Re: Notice of Completion & Avail of Draft Environmental Impact Report No. 2000-3213 site 1001-1029 Tiverton Ave 1020-1070 Glendon Ave 1015-1065 Glendon Ave

Re: Palazzo Westwood, Report No. 2000-3213

This letter is submitted in opposition to the proposed Palazzo Westwood Project and in response to the Draft Environmental Impact Report (EIR).

G. Olerich Comments on DEIR ENV 2000-3213 Palazzo Westwood." Page 19 of 19 plus 3 illustrations.

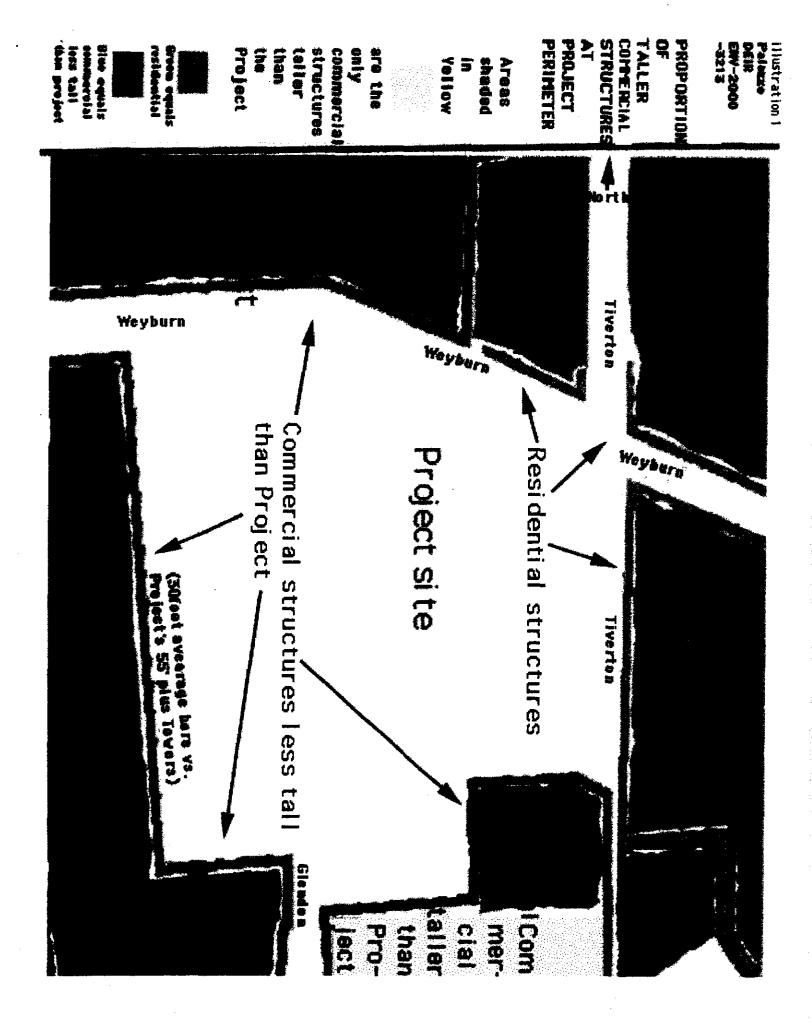
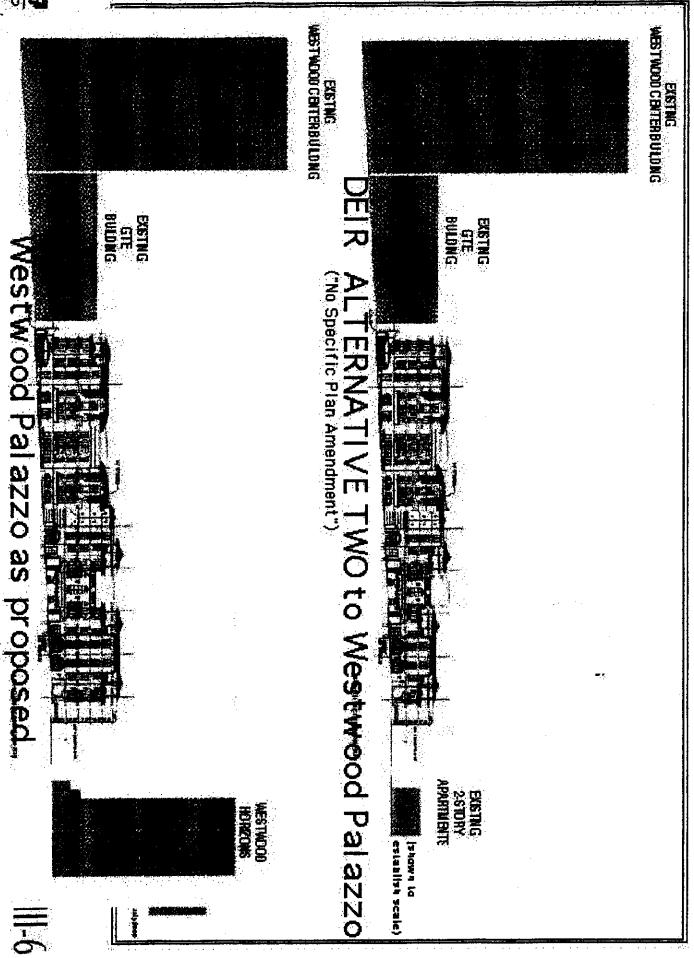
considerable preassure both legistlatively and possibly litigatively to have redevelopment of existing area low rise apartments with multifamily structures proportionate to that of the project as proposed. The DEIR should be revised and correct to reflect this.

Further the DEIR evidences it's obvious attempt to portray the proposed project in a favorable light by contradicting itself. Wheras at one point the DEIR states "...it would not encourage or contribute to pressures for redevelopment or alternative types of development in the area." One paragraph later it states "It may also spur revitalization or re-use of other underutilized sites in the Westwood area..." This indicates a complete redrafting of the DEIR by a completely independent unbiased third party would be in order.
